Work Order ID 55180

Item Name: Bolt

SPECIFICATION CONTROL DRAWING

DRAWING NO. D3977 REV. A
SHEET 1 OF 1
TITLE: BOLT (CARRIAGE), UNC
SCALE: NTS

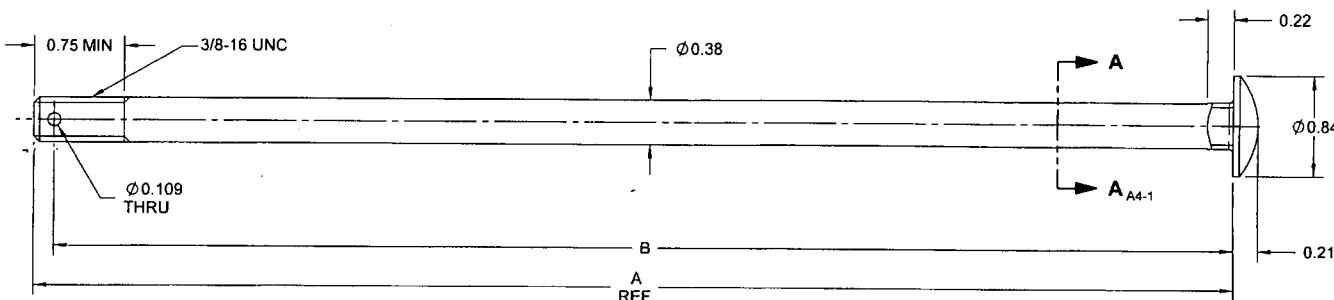
NCR: 55180		WORK ORDER NON-CONFORMANCE (NCR)						
DATE	STEP	Description of NC Section A	Corrective Action Section B			Verification Section C	Approval Chief Eng	Approval QC Inspector
			Initial Chief Eng	Action Description Chief Eng	Sign & Date			
10/01/19	120	BOLTS DIFFERS FROM DWG, PER ATTACHED EMAILS.	10/01/19 G31042	ACCEPTABLE DEVIATION PER ATTACHED EMAIL.	N/A	S 10/01/19	10/01/19 G31042	S 10/01/19

The dimensions are all within tolerance at the exception of the shank diameter. Per drawing, the diameter must be $\varnothing 0.38" +/- 0.03"$. The measurements I took are $\varnothing 0.370"$ (acceptable) and $\varnothing 0.331"$ to $\varnothing 0.340"$ (both under tolerance). I am just wondering if those would still be acceptable based on the fact that the loads will be distributed along the entire length of the shank rather than punctual. I have the impression that the inconsistencies are due to the manufacturing method as some seem forged while others seem casted.

The dimensions are all within tolerance at the exception of the shank diameter. Per drawing, the diameter must be $\varnothing 0.38"$ $+-0.03"$. The measurements I took are $\varnothing 0.370"$ (acceptable) and $\varnothing 0.331"$ to $\varnothing 0.340"$ (both under tolerance). I am just wondering if those would still be acceptable based on the fact that the loads will be distributed along the entire length of the shank rather than punctual. I have the impression that the inconsistencies are due to the manufacturing method as some seem forged while others seem casted.

The dimensions are all within tolerance at the exception of the shank diameter. Per drawing, the diameter must be $\varnothing 0.38" +/- 0.03"$. The measurements I took are $\varnothing 0.370"$ (acceptable) and $\varnothing 0.331"$ to $\varnothing 0.340"$ (both under tolerance). I am just wondering if those would still be acceptable based on the fact that the loads will be distributed along the entire length of the shank rather than punctual. I have the impression that the inconsistencies are due to the manufacturing method as some seem forged while others seem casted.

For what this part is used for, I don't see a problem with this deviation.

For what this part is used for, I don't see a problem with this deviation.
